Meeting Date: Tuesday 21 April 2015
Location: Committee Room 2, Level 5, Civic Centre, 1 Devlin Street, Ryde
Time: 5.00pm

Item		Page
1	CONFIRMATION OF MINUTES - Meeting held on 17 March 2015	1
2	46-48 GLADSTONE AVENUE, RYDE. LOTS F and G DP 32873. Local Development Application for demolition of existing structures and construction of a 3 storey residential flat building containing 12 apartments and car parking for 16 vehicles. LDA2013/0173.....	4
3	99 ELLIOTT AVENUE, EAST RYDE. LOT 393 DP 31574. Local Development Application for Demolition, new dual occupancy (attached). LDA2014/0311.....	155
4	36 SAMUEL STREET, RYDE - LOT 27 DP 4826. Development Application for demolition and construction of a new dual occupancy (attached). LDA2014/332.....	242

2 40 ANTHONY ROAD, DENISTONE – LOT 115 IN DP 305219. Development Application for a multi dwelling housing development containing 5 units and strata subdivision. LDA2014/0133.

Details of these changes have been shown on the Ground Floor Plan (A105 Revision H). The recommended condition No 55 includes additional details to ensure that construction occurs as per the amended plans. The above is considered satisfactory.

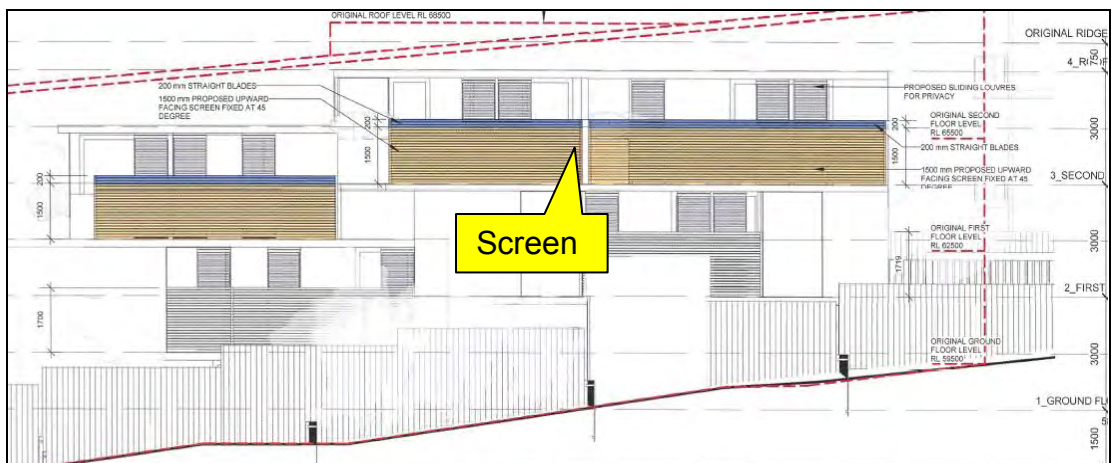
- (a) **Fence:** Boundary fence height to be increased to 2.4m with timber lapped and capped construction at applicant's cost.

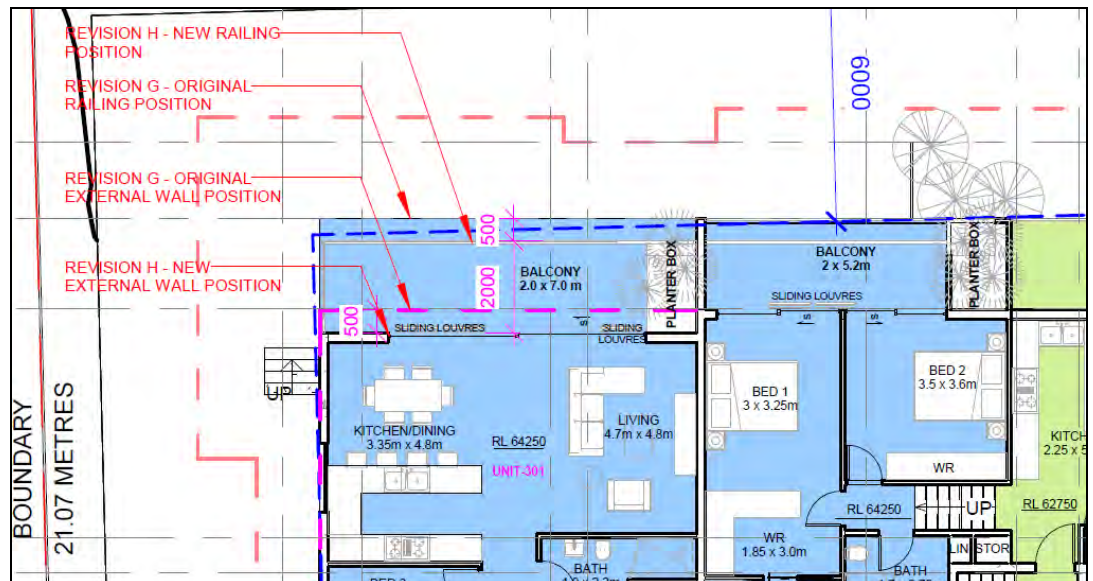
- (d) **Top floor setback:** The applicant undertook to explore amending the plans to increase the setback of the top floor (north eastern corner of the building) from the rear boundary by 500mm – 600mm. In relation to this matter the applicant was allowed to communicate with the objector after which plans were to be submitted to Council for re-notification and further review.

Accordingly the applicant has amended the plan to increase the setback of the building (including the balcony screen) on the second floor level. The applicant provided the plan to the objector for review. On 18 December 2014, an email was received from the neighbour raising no objection to the amended plans. The setback is shown marked on the plan shown below:

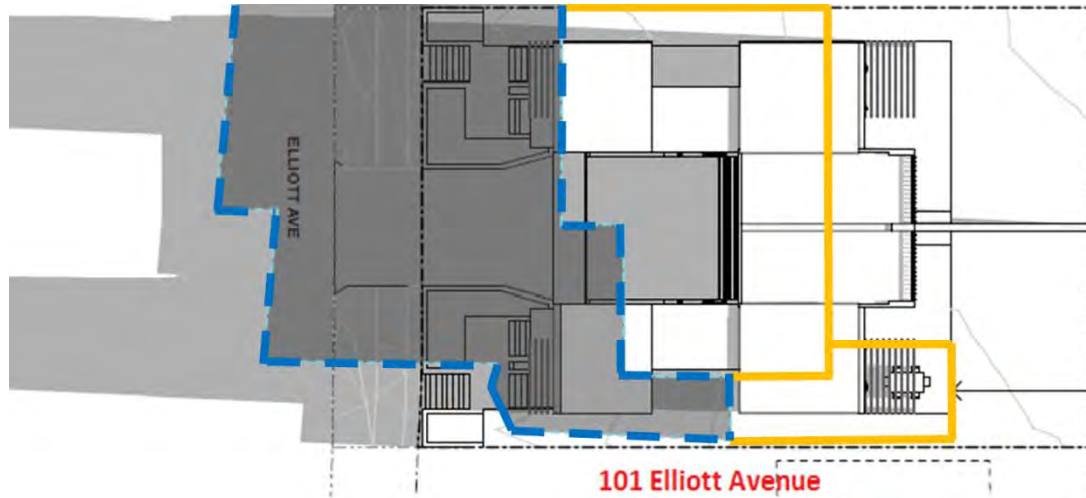
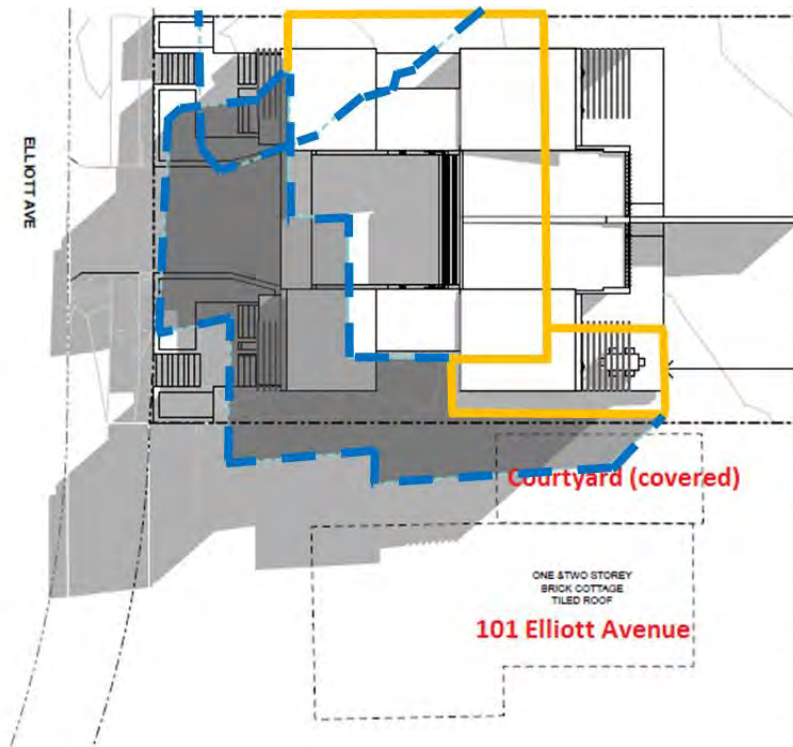
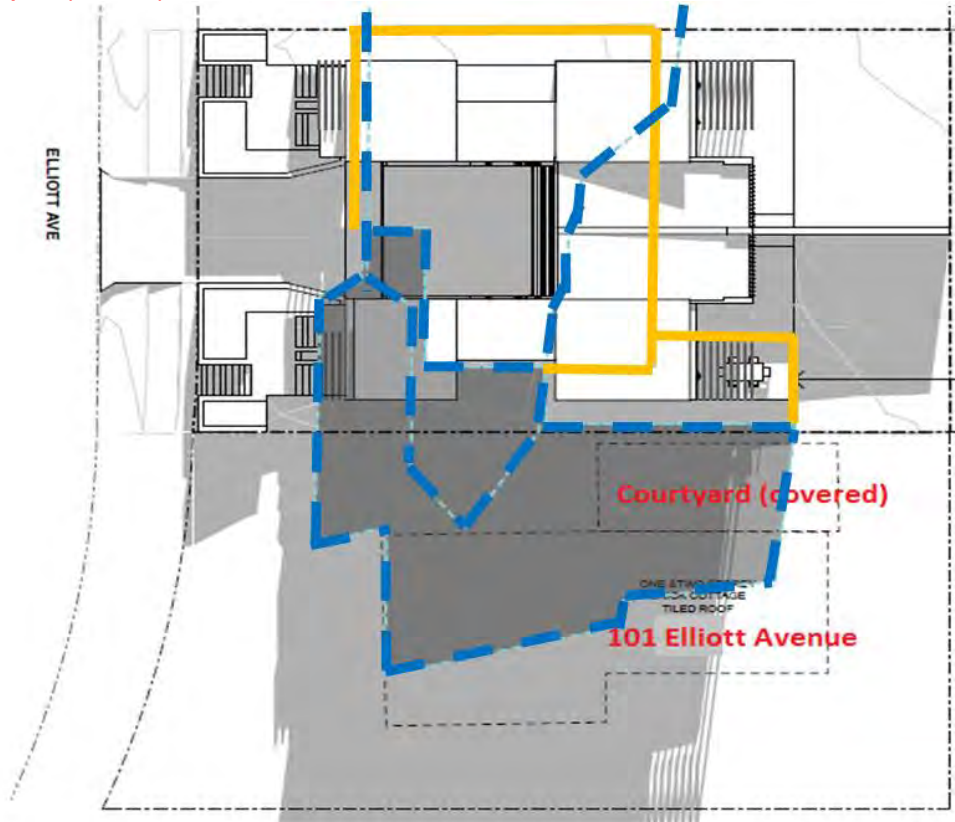
- *sunlight to at least 50% of the principal area of ground level private open space of adjacent properties is not reduced to less than two hours between 9am and 3pm on June 21, and*
- *windows to north-facing living areas of neighbouring dwellings receive at least 3 hours of sunlight between 9am and 3pm on 21 June over a portion of their surface, where this can be reasonably maintained given the orientation topography of the subject and neighbouring sites.*

As demonstrated in the shadow diagrams submitted as part of the development application (see below), the proposed development will have some overshadowing impacts (midday onwards) on the neighbouring dwelling at 101 Elliott Avenue:

As demonstrated by the shadow diagrams provided, the rear courtyard of 101 Elliott Avenue will be subject to overshadowing between midday and 3pm on the 21st June. However, between 9am and midday, the principal area of ground level private open space, ie the rear courtyard will not be overshadowed and will achieve more than the minimum two hours sunlight as prescribed in the Ryde DCP 2014.

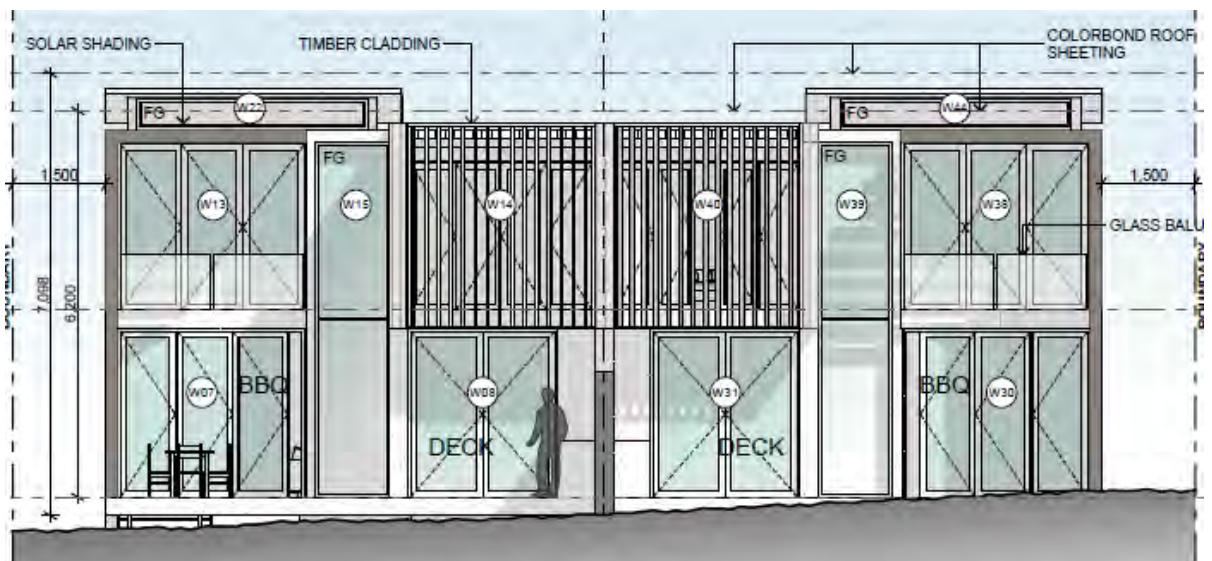
- *Privacy - Concerns are raised regarding overlooking and noise impacts from the windows within the rear elevation of the development affecting no. 34 Lumsdaine Avenue. Concerns are also raised regarding the potential for large number of people to occupy the building.*

Comment: The north facing (rear) windows of both units - shown in the north elevation drawing (below), relate to bedrooms on the first floor which are used infrequently and predominantly at night. Overlooking from bedroom windows is less of a concern than overlooking from the windows of other habitable rooms, because of the nature of use of these rooms.

Figure 3 – Plan of proposed development and landscaping on the subject site. Diagram shows the significant amount of deep soil area provided in the rear yard, despite not meeting the minimum 8m x 8m dimension outlined in the Ryde DCP 2010.

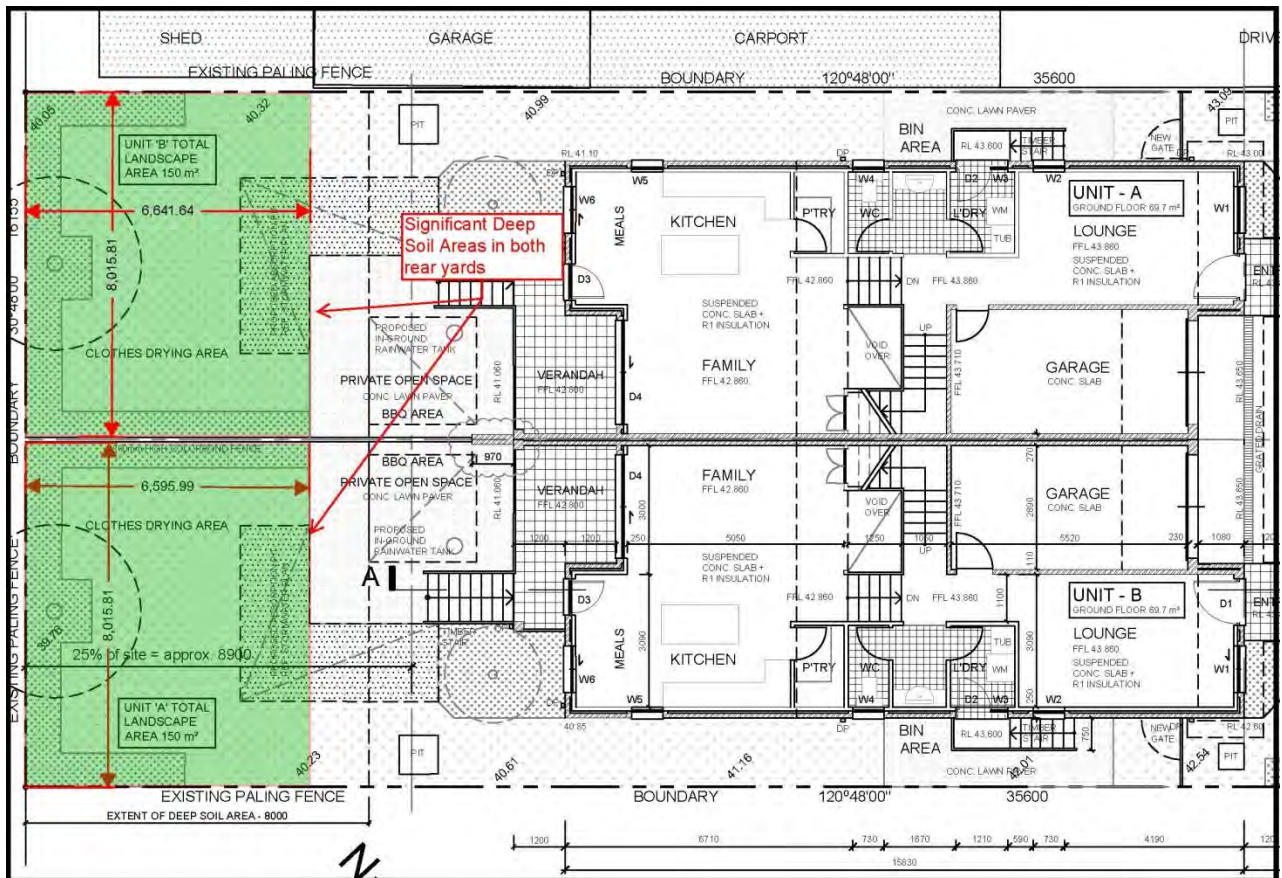
- The non-compliance is considered to be relatively minor, just falling short of the required dimension by 1.4m due to the rear paved area encroaching slightly on the deep soil area. As noted above despite not meeting the minimum dimensions, the deep soil area provided at the rear is significantly more (12.5%) than the control requires, providing for approximately 224.40m² of deep soil area (refer **Figure 3**).

Figure 4 – This diagram shows the proposed areas of cut and fill on the subject site. Noted is how the majority of the building is raised to comply with the 1:100 year flood level plus 500mm freeboard which is indicated in the following figure.

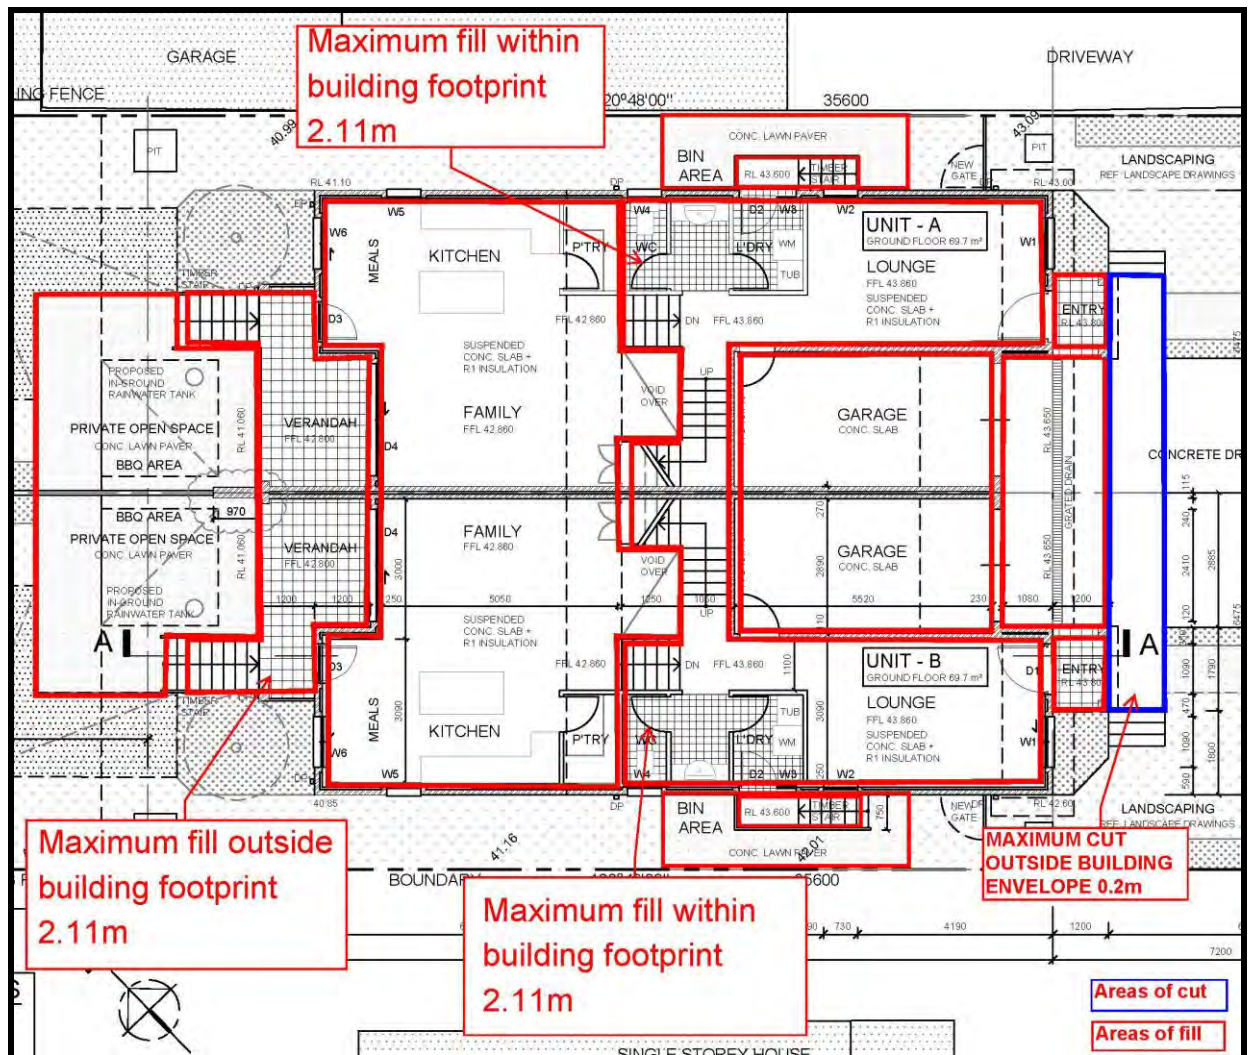
- As indicated in **Figure 4** the maximum fill within the building footprint is exceeded approximately halfway down the site within the room marked WC. It is considered that the elevated floor levels will not result in a loss of privacy for neighbours as beyond this point the building steps down to the main living areas which are orientated towards the rear of the site.
- The level of fill is common along the north-western side of Samuel Street due to the slope away from street and flood implications of the land. As such, the existing building on the subject site has similar levels of fill.
- The proposal includes a suspended, so no solid soil fill will be used. Accordingly, existing ground level is reasonably maintained.

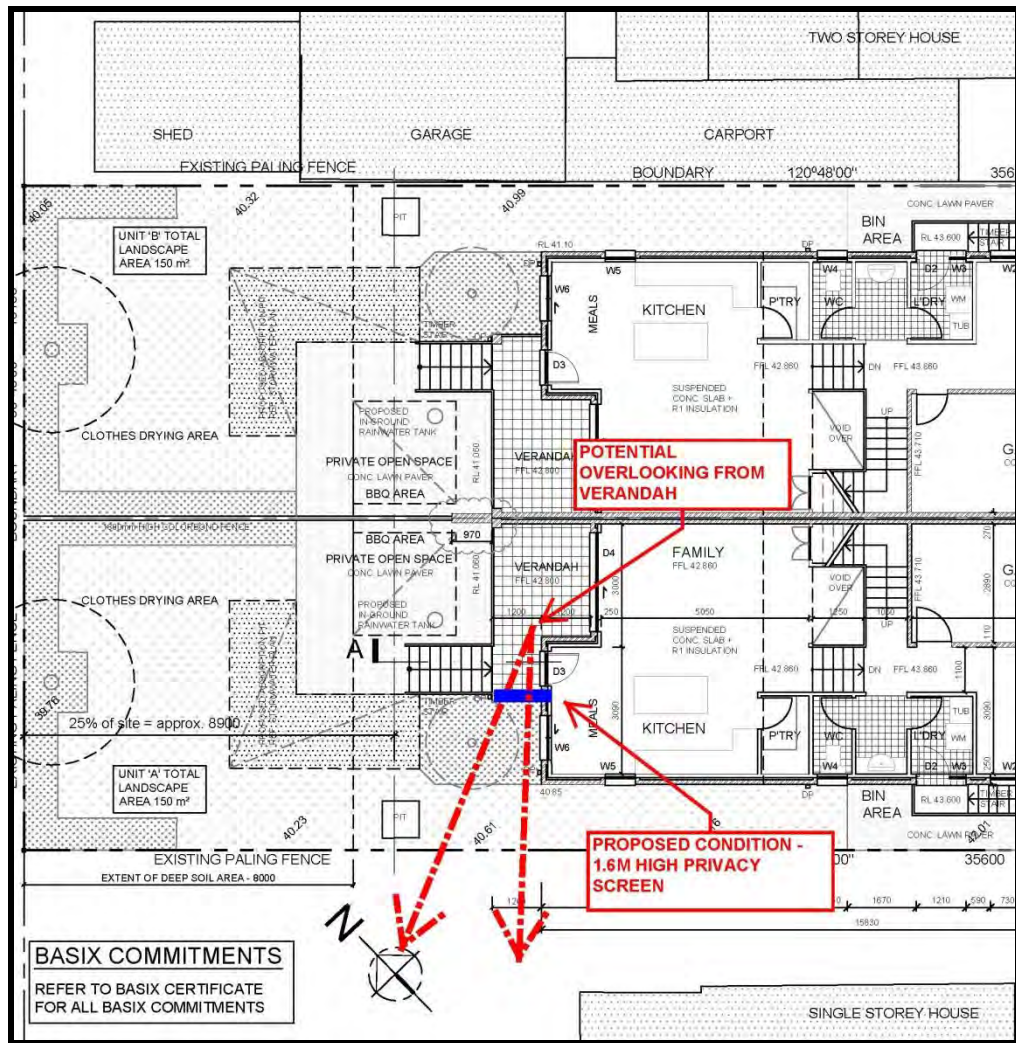
As noted in the letter for additional information to the applicant, concern was raised in relation to visual privacy impacts within the development resulting from the proposed elevated verandahs. It is acknowledged that the revised plans detailed the addition of a new 970mm blade wall between the dwellings to mitigate these potential impacts. Nevertheless it is considered that the internal dividing fence could provide further privacy by the imposition of a condition of consent requiring 300mm of lattice screening (Refer **Figure 7**).

In addition to internal overlooking, there is considered to be some opportunity for overlooking of adjoining property to the south west of the site, particularly from the rear verandah of Unit A given its elevated nature. Overlooking to the adjoining property to the north-east is not considered to be a concern due to the adjoining property including garages and outbuilding immediately adjacent to the Unit B verandah (refer to **Figure 8** below). To address overlooking from the Unit A verandah to the adjoining property to the south-west, the following condition of consent is recommended (see condition 35):

Figure 8 – The above figure illustrates each privacy feature that has been either conditioned or proposed by the applicant (Privacy Blade Wall)
Source: Submitted ground floor plan edited by CPS

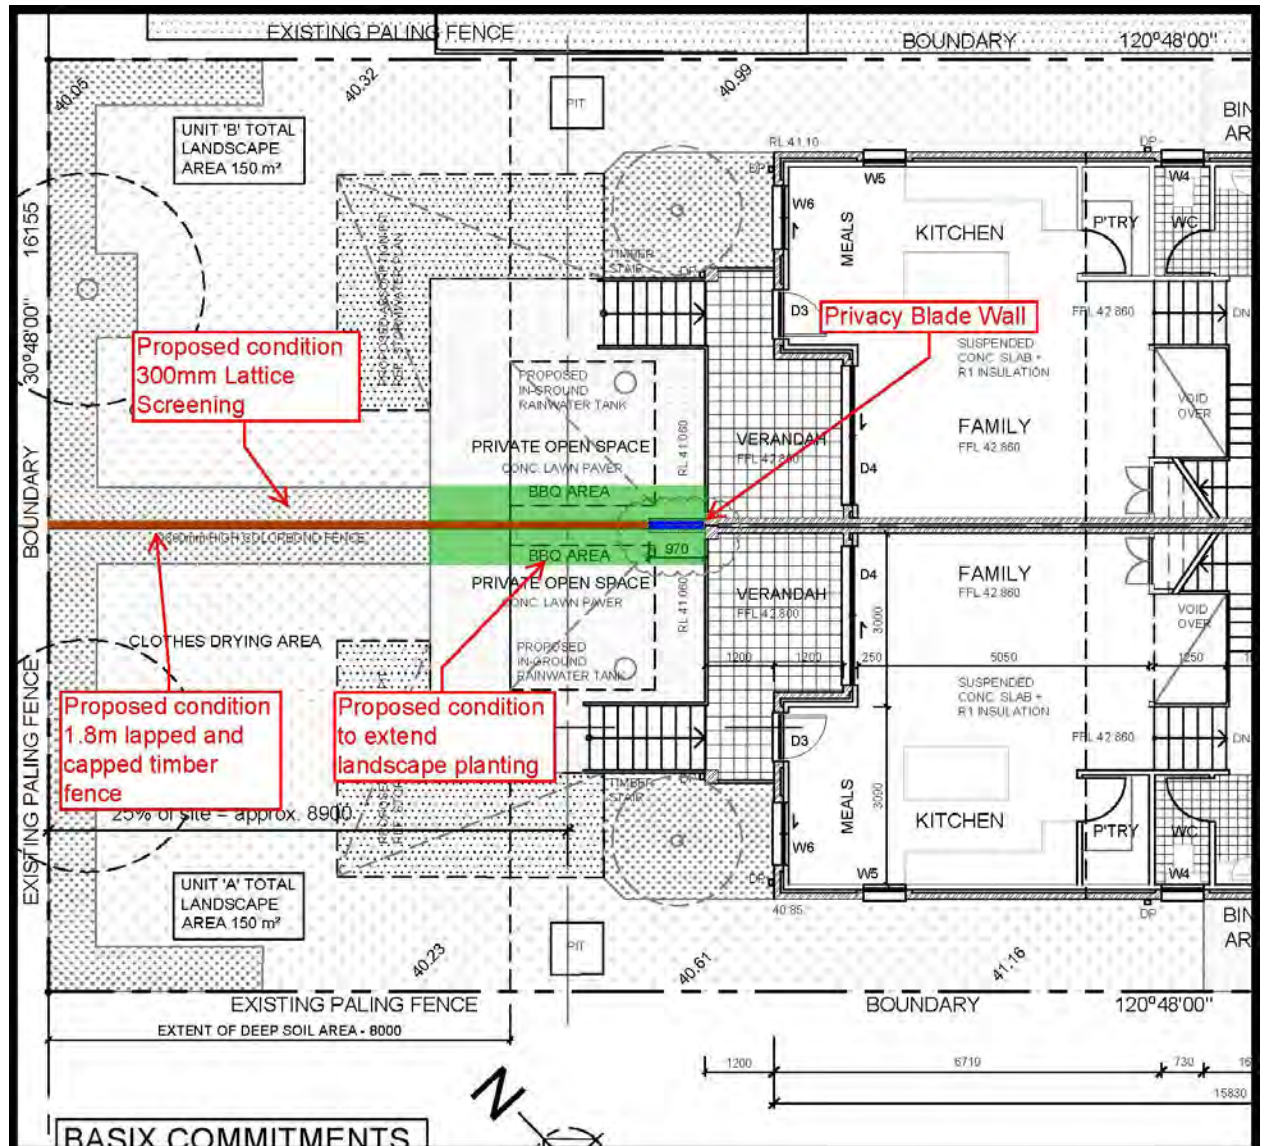
Council's consultant Landscape Architect has raised concerns given the elevated level of the rear terrace area of each unit of the dual occupancy, it is considered that privacy/overlooking impacts could be further mitigated by the continuation of the boundary screening hedges located along the side boundaries so as to preclude views towards the neighbouring private open space (Refer **Figure 8**).
